**QUESTIONS AND ANSWERS
RFP 25-01 GO901 TICKET VENDING MACHINE**

MARCH 6, 2025

Pictures for Question 54.

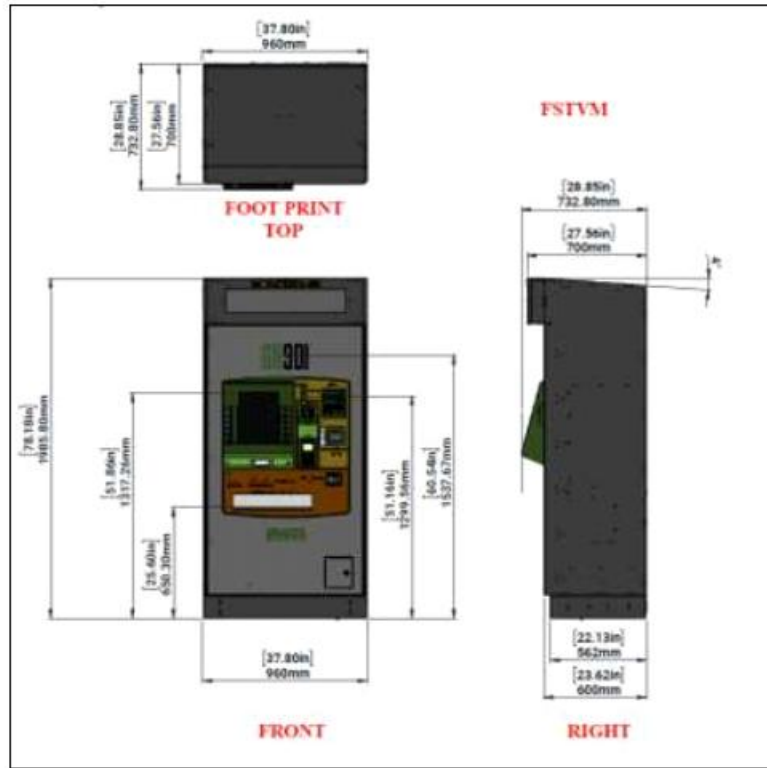
MATA states that the agency currently has 8 TVMs, could MATA please provide the name of the current supplier of TVMs and screenshots/examples of the user interface so we can ensure delivery of the customer experience MATA has in mind?

American Eagle / Datamatics are the suppliers of the current TVMs. A picture of the user interface is attached hereto.

Figure 2-3: FSTVM and CTVM overview

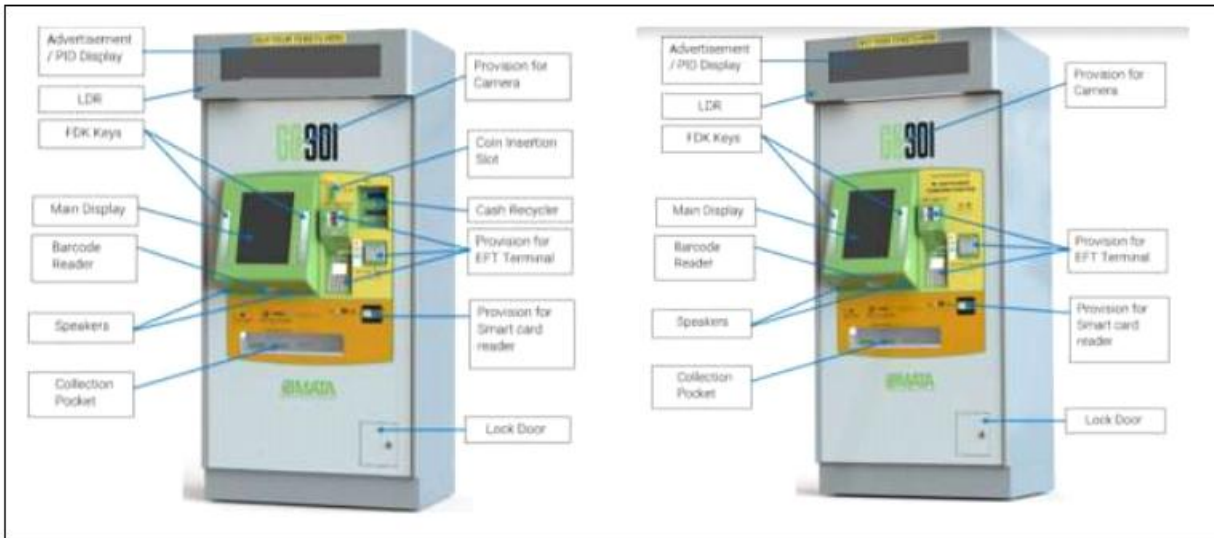
Can the agency provide the specifications of the 8 units that are already purchased? (dimension, list of components, UI, ...)

Dimensions (H x W x D) 1985 H X 960 W X 700 D (mm). See attached FSTVM/CTVM specifications
